Bid 633
New HVAC Modernization Project for Channel Islands High School

BID CLARIFICATION ADDENDUM #3

Dated: December 9, 2020

Revised Ductsox Detail

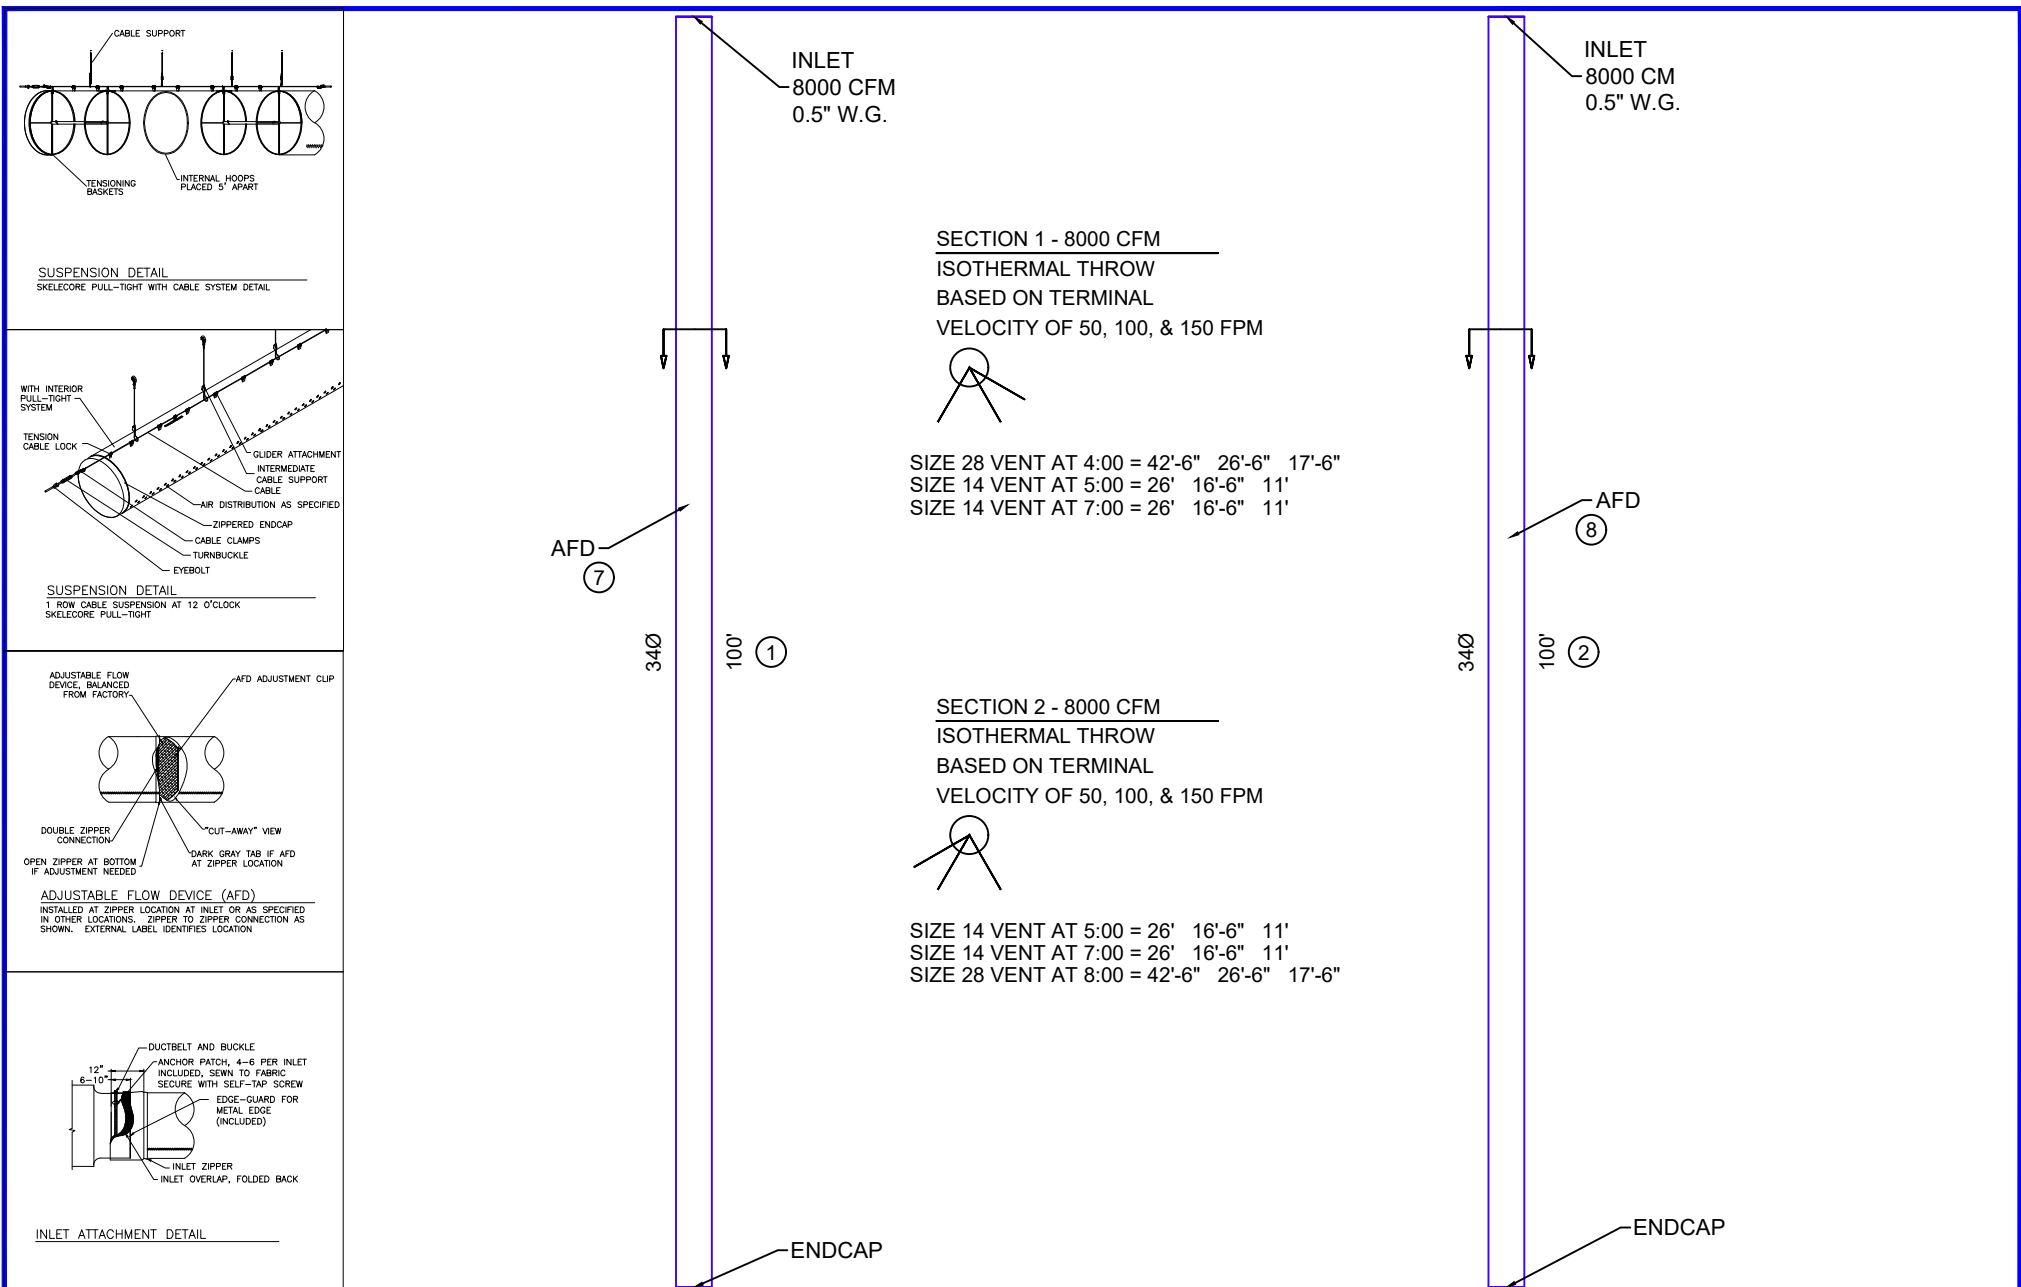
- 7) Please refer to Attachment E for Architect/Engineer Narrative, and [District's website](#) for Revised (Version 3) Bid Set Drawings & Spec Book
- 8) Please refer to Attachment F for revised Ductsox detail (1/M-601).

DRAWING NUMBER DS19-1573			REV 7	DESCRIPTION CHANGE OF LAYOUT	BY LJB		DATE 26 MAY 2020
	DRAWN BY KCS			REV 8	DESCRIPTION REVISED VENT DESIGN	BY KCS		DATE 04 DEC 2020
DATE 11 JUN 2019			REV 6	DESCRIPTION REVISED FOR 16,000 CFM	BY KCS		DATE 08 MAY 2020
